HONU'APO

OU1 Design Change and Modification Sheet: Change/Modification # 013

OU1 Design Change and Modification Sheet:

OU1 Design Change and Modification Sheet: Change/Modification # 015

CERTIFICATE OF SURVEY NO. 2332

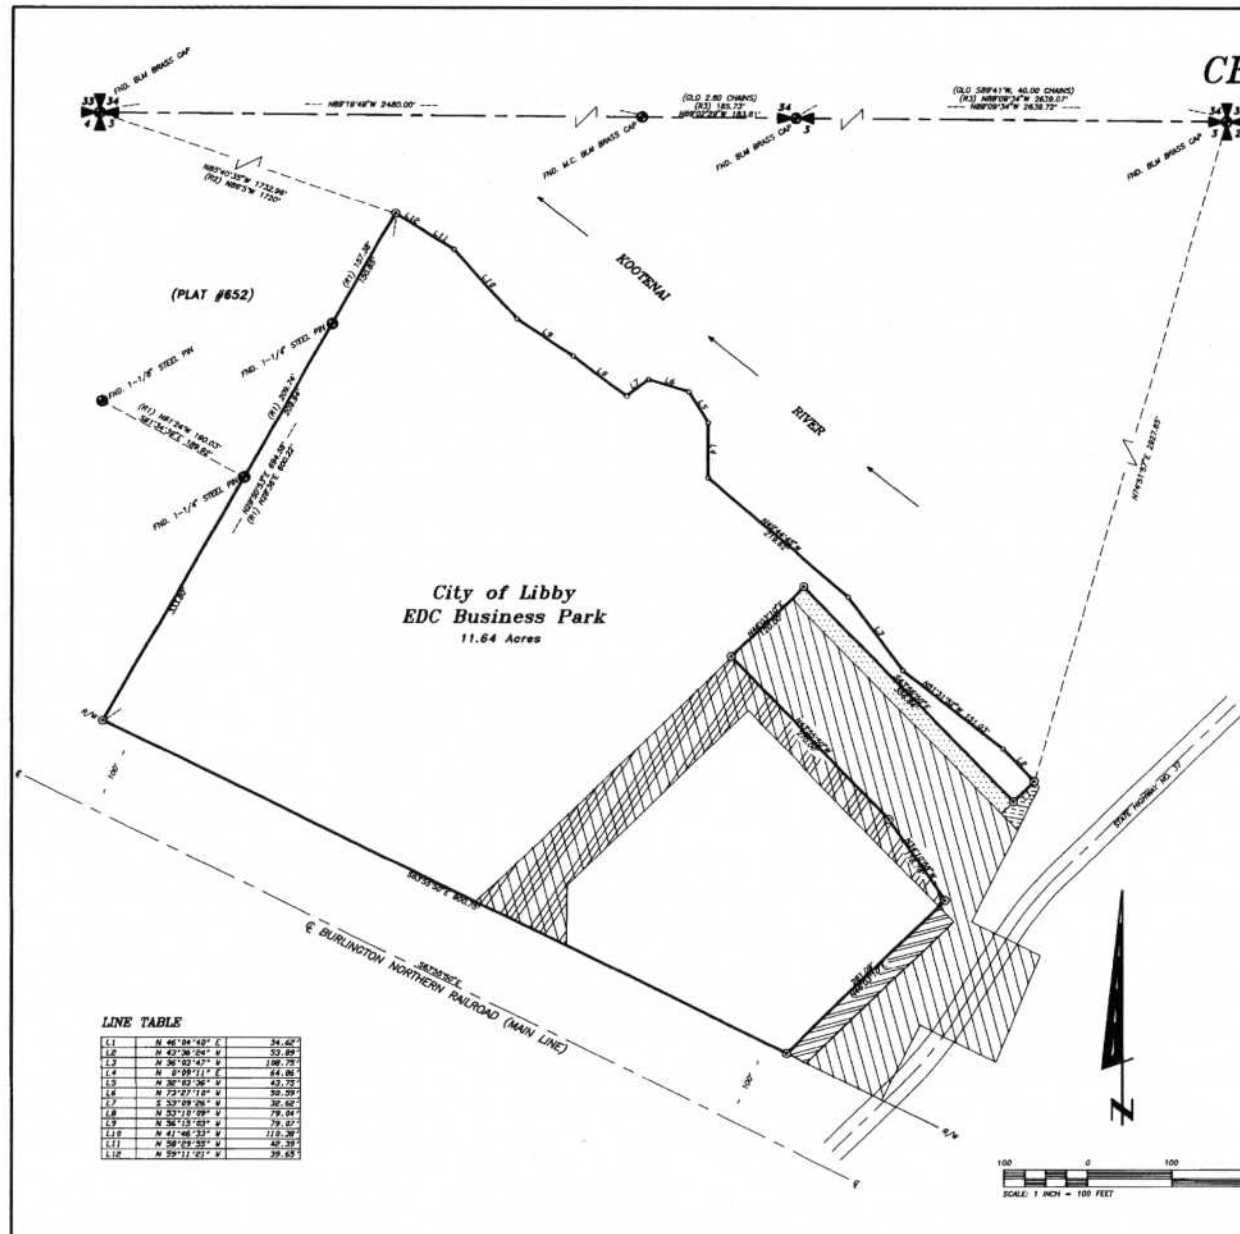
Modify the excavation depths and finish elevations along the southern property line of Area 1 due to discrepancy in the surveyed and staked property line versus the WGN design. The modification requires additional excavation along portion of the property line to assure an 18" cap, upon completion. And, the blending of the site's contours to the adjacent BNSF property along the referenced property line.

See the attached surveys and the email below for an explanation of the property line discrepancy between OU1 and the BNSF property.

Attached are two different surveys, the first survey No. 1828 done in 1991 by Davis Surveying Inc. is what we used for the original boundary on the site survey we did in 2010. At the time of the site survey, we only found a couple of monuments located on the northern end of the west boundary line, from those found monuments the rest of the boundaries were retraced by record according to the distances and angles shown on the 1991 survey and associated deeds. This year when we were contracted to physically mark the south (railroad right of way) and west boundary (part of the OU1 contract) we marked the boundaries according to the existing JRS property corners along the rail road right of way as shown on survey no. 2332 done in 1995 (the original Davis corner was destroyed or removed). On the attached surveys I have highlighted the distances on the west boundary where the discrepancy is located, as for why there is a discrepancy I do not know. My experience with railroad right of ways usually involves differences as there are relatively no controlling monuments to establish the railroad right of ways. What is generally used to establish railroad right of way is locating the centerline of the existing main line and offsetting the record distance, in this case 100 ft. It's possible that the JRS used this method of locating a set of "main line" tracks to establish right of way centerline, (there is no other evidence on the JRS survey) but that is only my speculation. As for the older 1991 Davis survey, it appears that the right of way boundary was created using a combination of physically locating the "main line" (which may or may not have been the same "main line" as the JRS survey) and finding controlling monuments from a previous Ninneman Engineering survey located further west of the boundary, as shown on the survey.
